Letter No. HBT-1648-SO-NCR-2025/0441

Name of Work: Improvement to Yeola Nandgaon Pilkhod SH-25 Road (EPC NSK-II (Pkg-20A)) in the state of Maharashtra on EPC Mode. **Subject: Regarding Unsuitable material for Emb. and subgrade layer dumped at site.**

Name of Work: NSK-II (20A) Improvement to Yevla to Nandgaon Pilkhod Road SH- 25 Road Dist. Nashik.																			
Authority Maharashtra State Infrastructure Development Corporation (MSIDC)	Authority Engineer Rodic Consultants Pvt. Ltd. in JV with M/s Geo Designs and Research Pvt. Ltd	ITF	Rajureshwar Infrastructure (75%) in JV with V.P. Sethi Construction Pvt. Ltd. (25%)																
NCR No. C²																			
Department Audited: HW/STR/QC/Safety																			
NCR Date: - 10.04.2025		NCR No. 032																	
Resident Engineer:																			
Team leader:																			
Non-Conformance statement:(Ref Clause 11.12 of CA) Unsuitable Material dumped for EMB and Sub-Grade Layer are not meeting the criteria set forth in clause 305.2.1.4 of MoRT&H. From Ch. 136+100 to 136+650 LHS 128+900 to 129+100 RHS and Ch. 127+000 to 127+400 RHS.																			
Objective Evidence: - Site Photograph																			
EPC Co

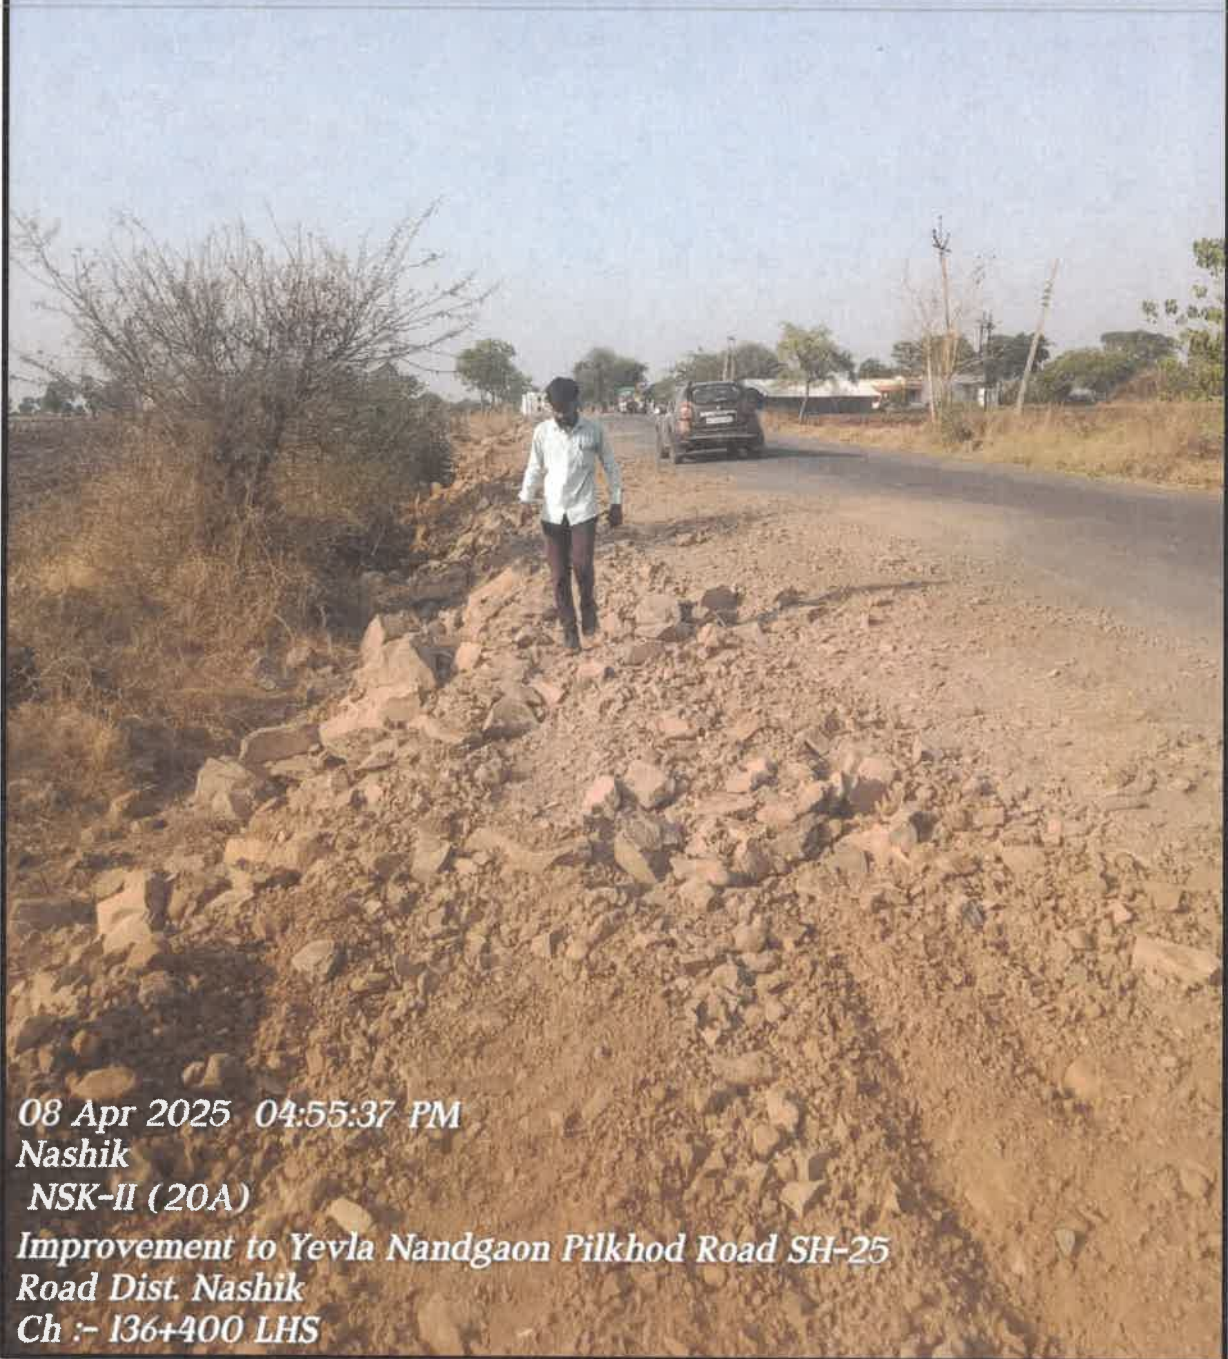
Please find here enclosed NCR no.2 issued vide CA clause 11.12 of Article 11 regarding unsuitable material dumped at Ch. 128+900 to 129+100 RHS, 127+000 to 127+400 RHS & 136+100 to 136+650 LHS for Embankment and Subgrade work which are not Conforming to MoRT&H clause 305.2.1.

Ch :- 136+400 LHS

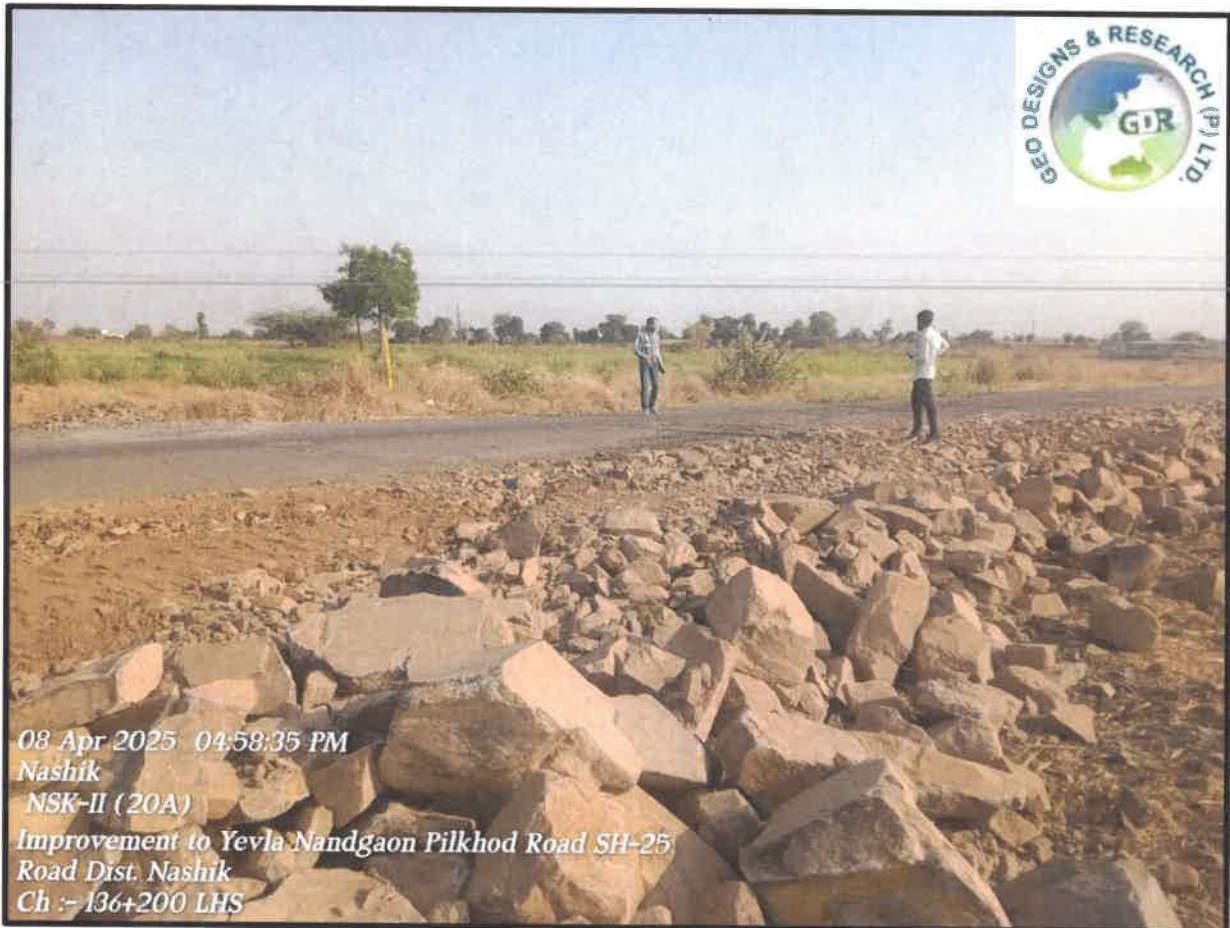
Hence, remove & relay with fresh material conforming to above mention clause.
